Water Investigations Branch

September 27, 74

Groundwater Supply - Proposed Subdivision of
Section 2 & 3, Range 6, Cedar District (Yellow Point)

FIGURE 1

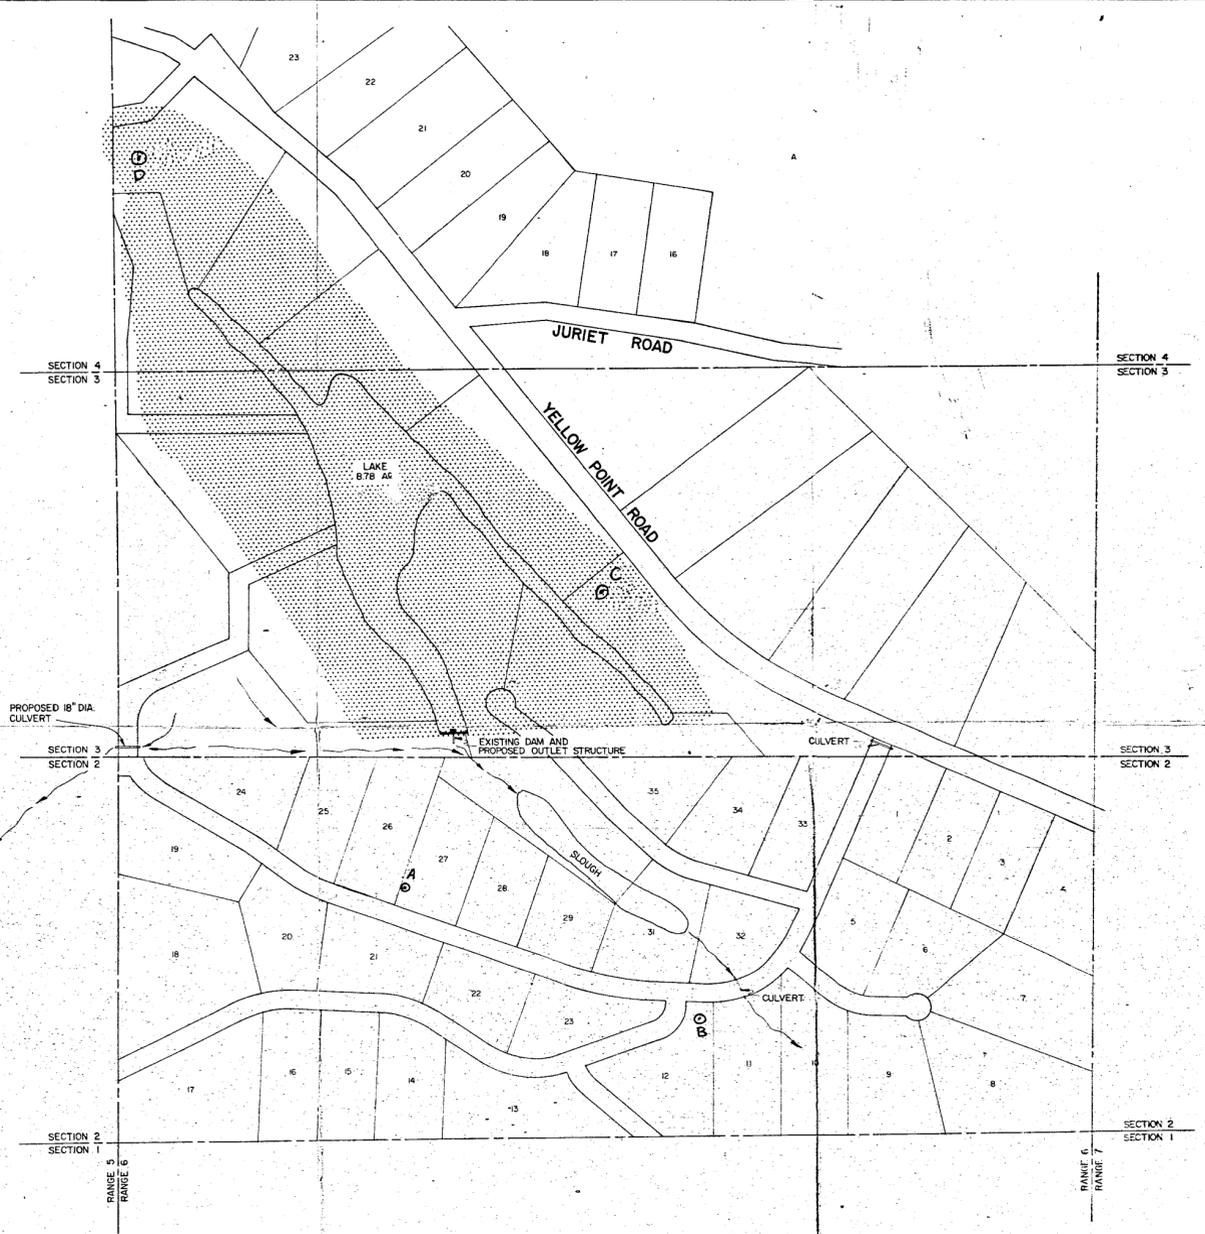
In the evening I called in to see Mr. W.J. Williams, owner, operator of Island Well Drilling and driller of the two wells Mr. Anderson and I had located earlier in the day. He provided me with the well locations of two additional wells drilled this year on the Section 3 subdivision considerably to the north (see figure 1) and drill logs for all four wells (attached).

Figure 1 shows the drainage to be predominant to the southeast which drains to Priest Creek. On the basis of the aerial photographs and existing maps and a field reconnaissance I would tentatively suggest that natural drainage may, in fact, be to the northwest towards Quesnel Lake and only the southeast corner of Section 2 may be affected by drainage towards Priest Creek. Only a detailed contour map which I do not have will resolve this question. However, there is enough doubt to defer placement of any proposed observation wells outside the

2. We should also request that the developer of the Subdivision on Section 3 be approached with the same request for wells c and d on Figure 1. However, as the lot size is to be five acres, we would recommend a restrictive radius around the well of 100 feet ~~inland~~^{instead} of 50 feet. As this subdivision ^{instead} on Section 3 has not yet been registered I believe we should have a better chance of obtaining the developers approval for this.

Figure 2

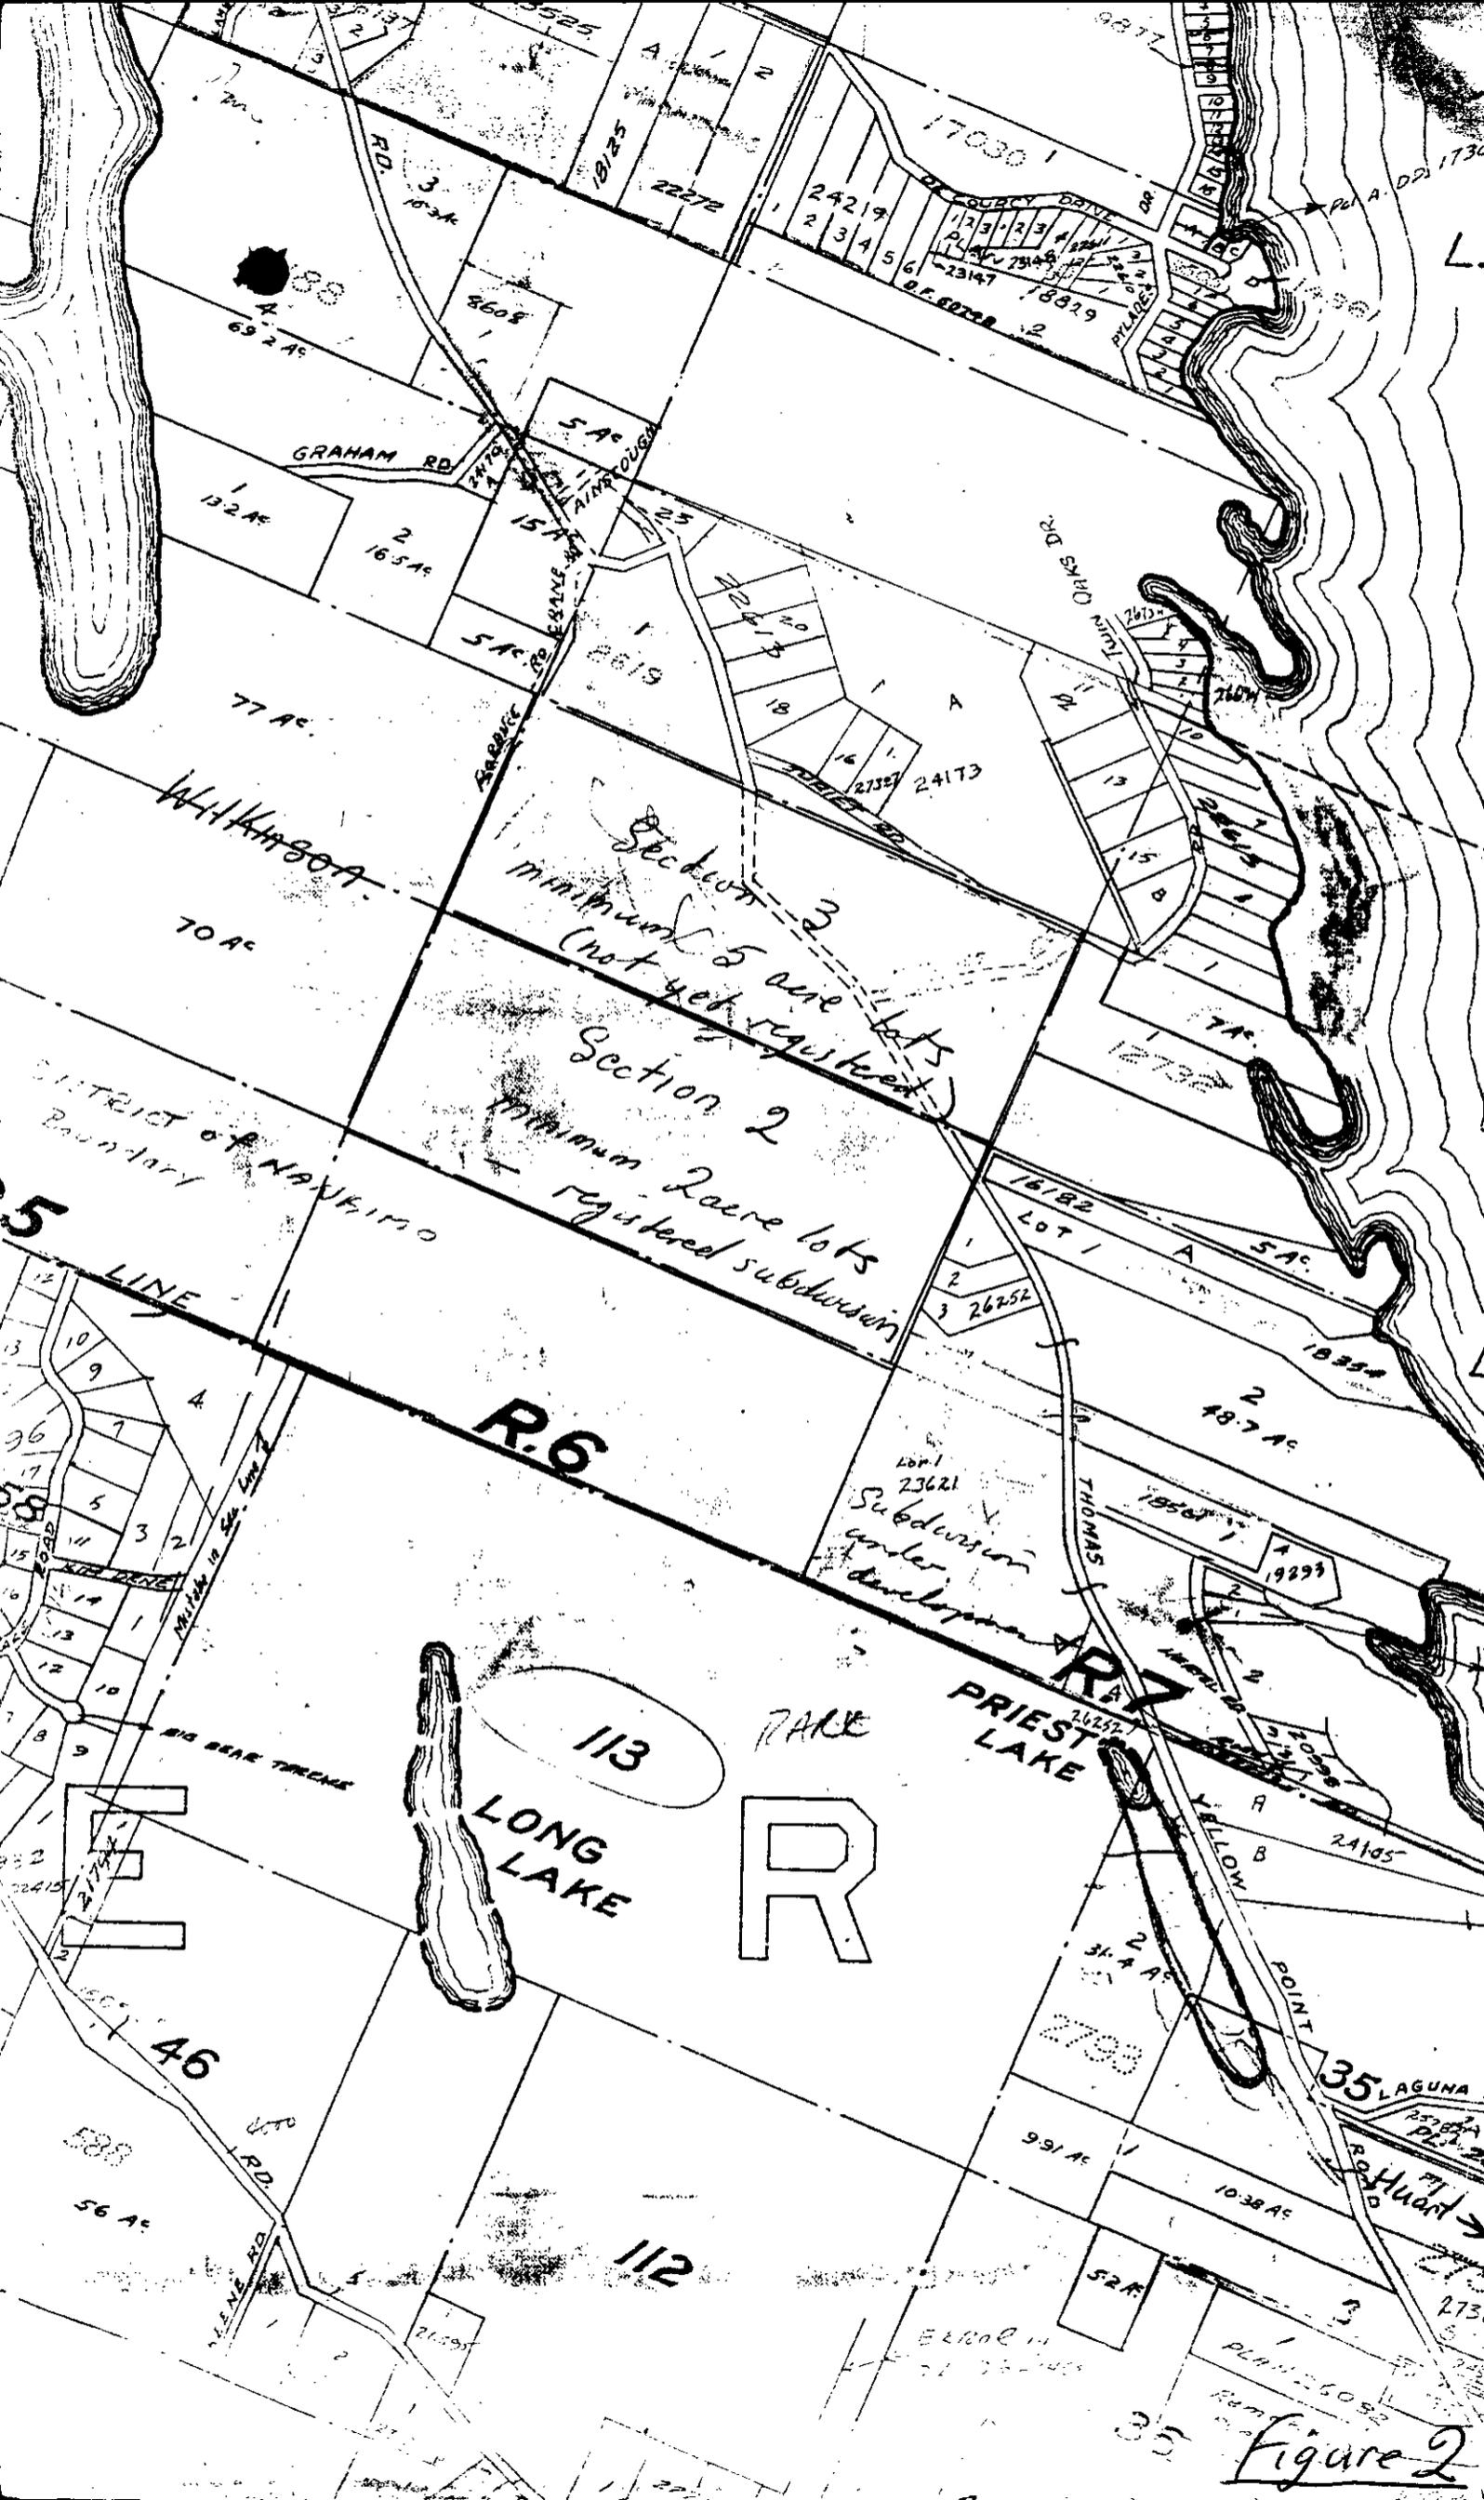
Mr. Anderson also showed me the locations of Mr. Wilkinson's property and Mr. J.P. Huart's property, two of the principal objections to the subdivision plan (see Figure 2 for location of these two properties).
